4th Session SEISMIC EFFICIENCY OF LARGE STRUCTURES (RECOMMENDATIONS, CHECKING AND SURVEILLANCE)

DISCUSSION

Paper 4/1 R. PRISCU, A. POPOVICI, C. STERE - ROMANIA

"The Consequences of Partially Grouted Joints Upon the Arch Dam Seismic Behaviour"

Principal stresses σ_1 , σ_2 produced by hydrostatic pressure, according to the three analysed variants.

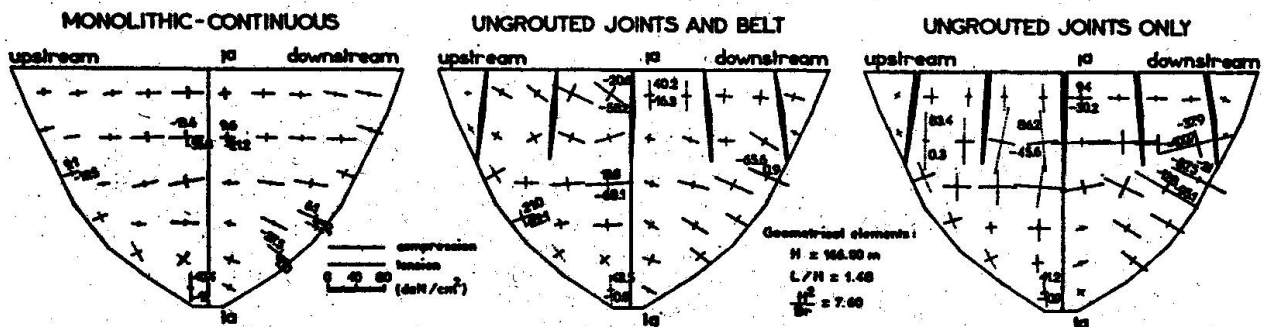
I believe that the ordinates of fig. 4 are all ten times too large and a decimal point should be added; also in fig. 7 I find it difficult to understand the large horizontal stresses in the area where the joints are ungrouted.

The dam structure discretization has been carried out through Clough-Fellipa thin shell finite elements, according to the SAP IV program /6/. The computer program gives out stresses within the element centers. Therefore, in fig. 7, the horizontal and vertical stresses are represented for the medium cross-section of the dam central block (cross-section a-a).

As to have a more complete picture upon the stress distribution of the three considered schemes (monolithic, partial grouted joints with and without stiffening crest belt), in the hereby enclosed figure the principal stresses σ_1 , σ_2 are presented, yielded by the hydrostatic pressure with the reservoir level up to the dam crest.
